**CHAPTER 11**  
**REQUEST FOR WAIVER FROM ACCESSIBILITY REQUIREMENTS**  
**CHAPTER 553, PART V, FLORIDA STATUTES**  
**August 1999**

MODIFICATION PER  
ADA CODE REQUIREMENTS  
CHANGE OF USE

**SLIP N' SLIDE RECORDS**  
919 4TH STREET  
MIAMI BEACH, FL 33139

DRAWING No. 10-2504 A-3  
SHEET A-4

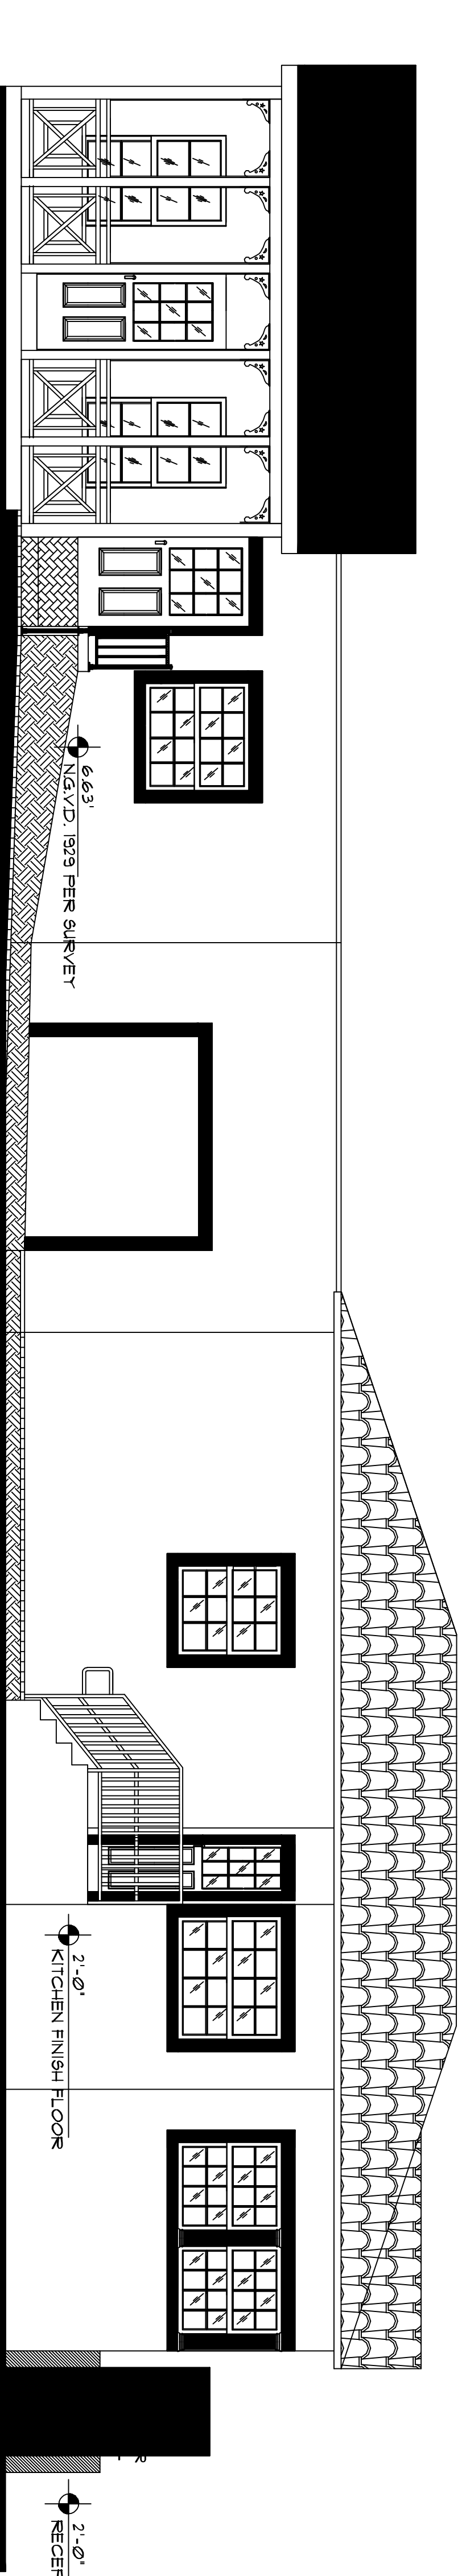
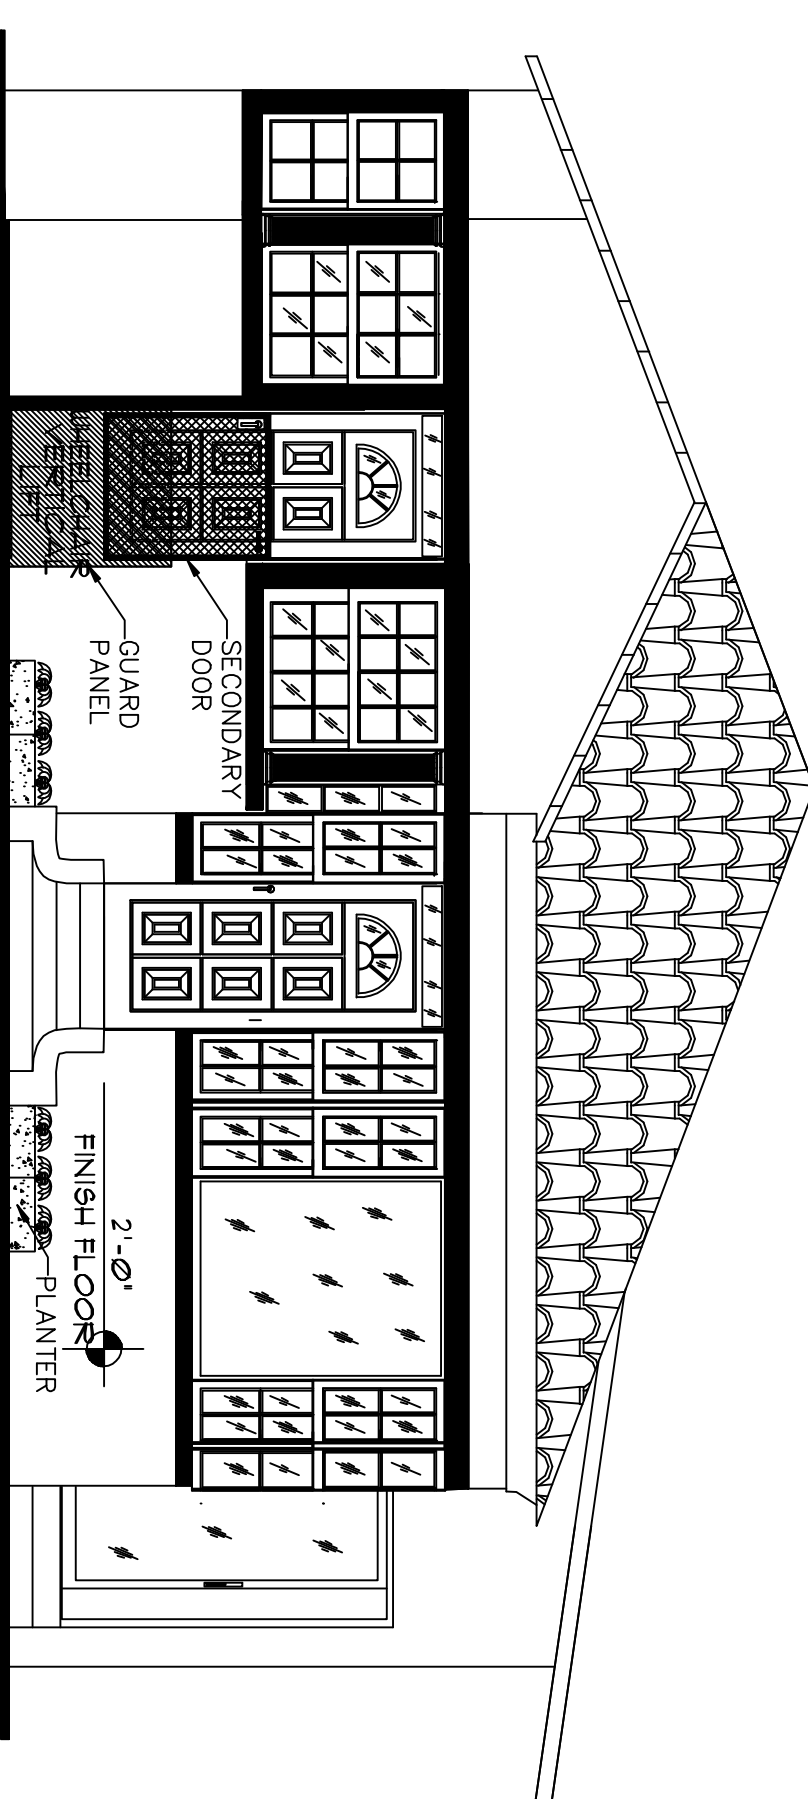
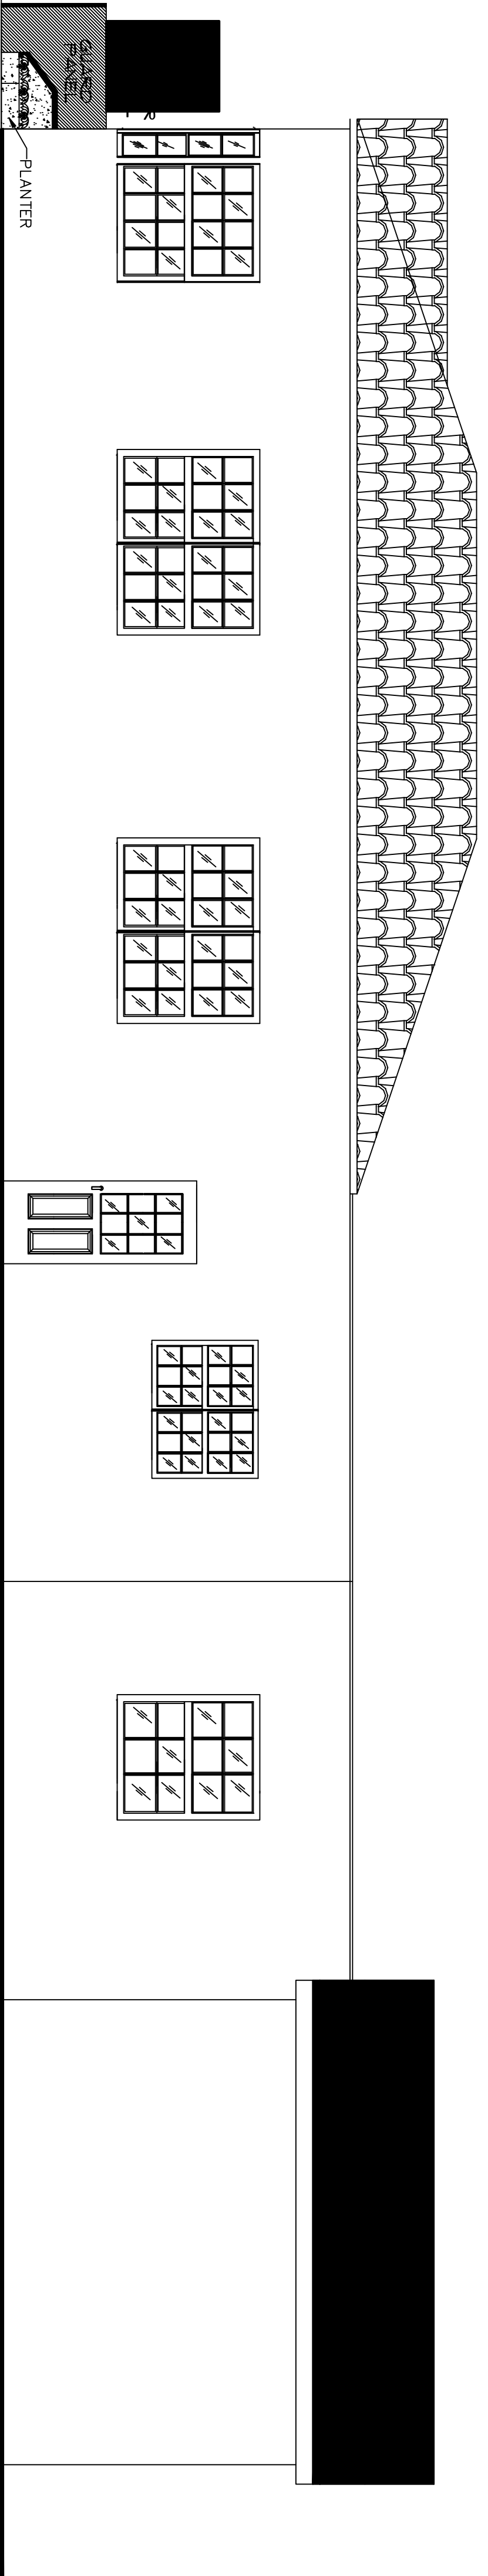
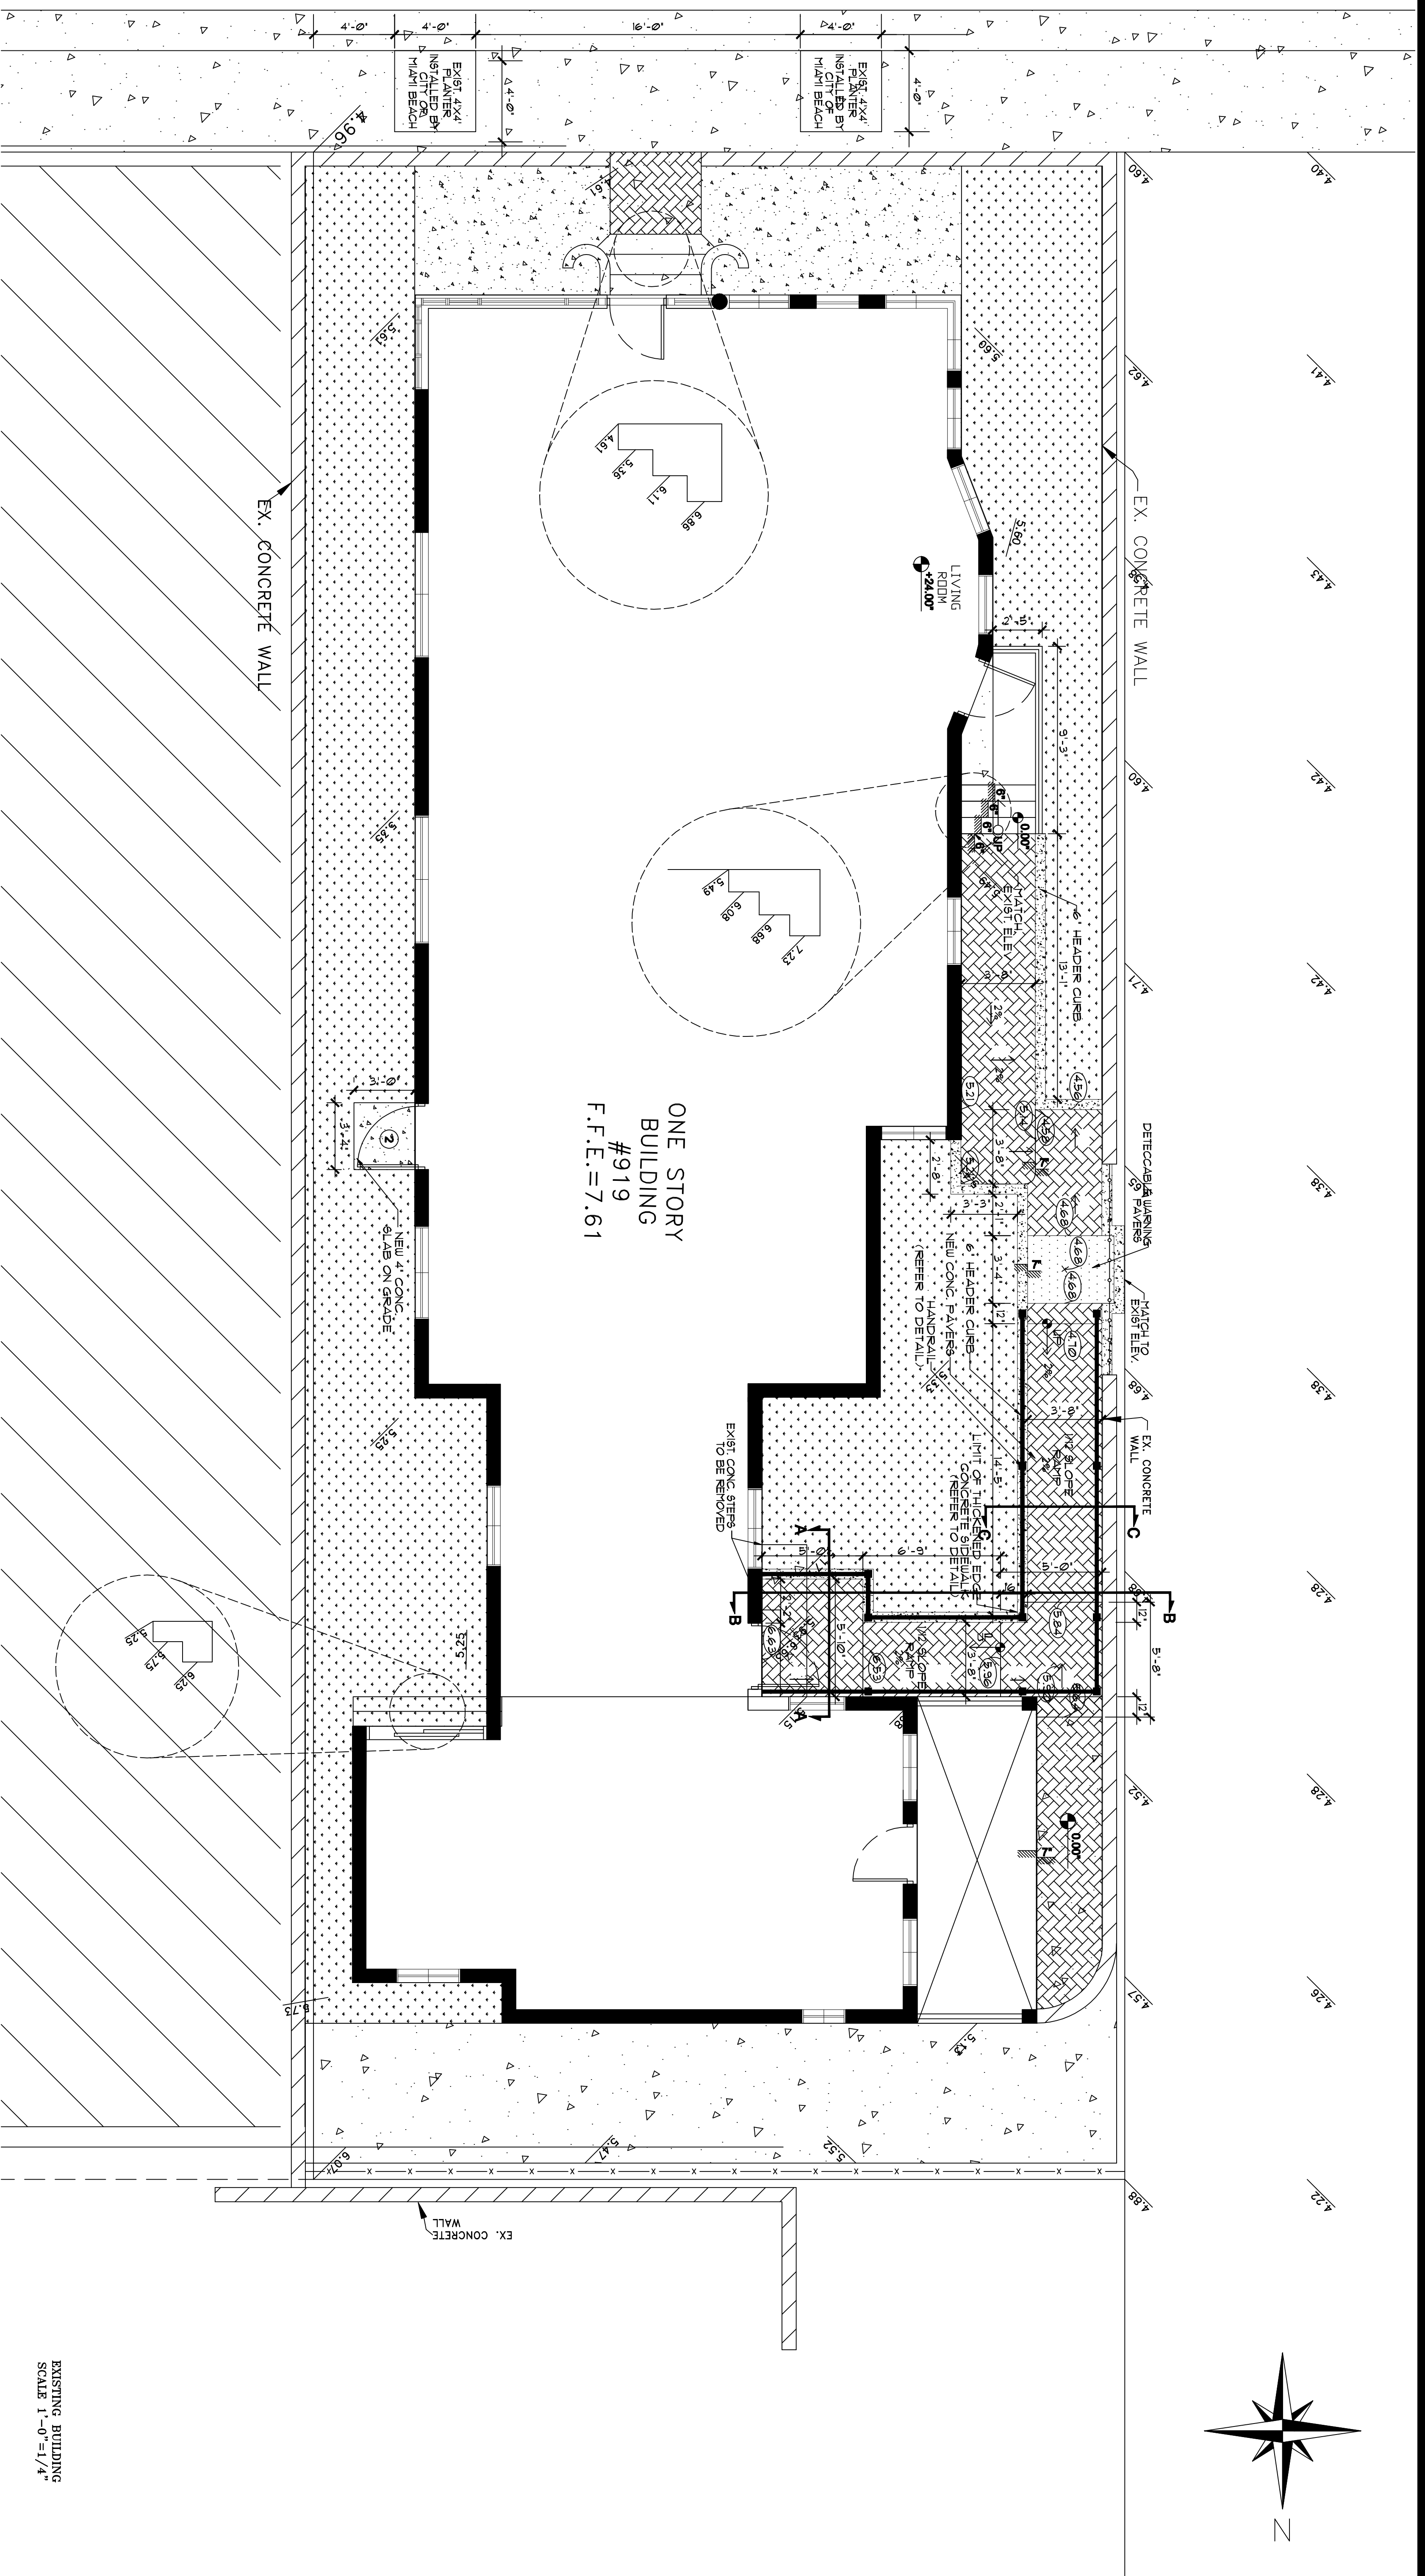
Front elevation does not show proposed railing or proposed "lift".

sheet a-2:

1. the west elevation detail shows handrail/guardrail, this design does not comply with the ffpc 07 ed chap 7, rectify

sheet a-2:

1. the west elevation detail shows handrail/guardrail, this design does not comply with the ffpc 07 ed chap 7, rectify (SHOW DETAIL DRAWING OF THE HANDRAIL & GUARDRAIL PER THE FFPC 07 ED 7.2.2.4.4 & 7.2.2.4.5)
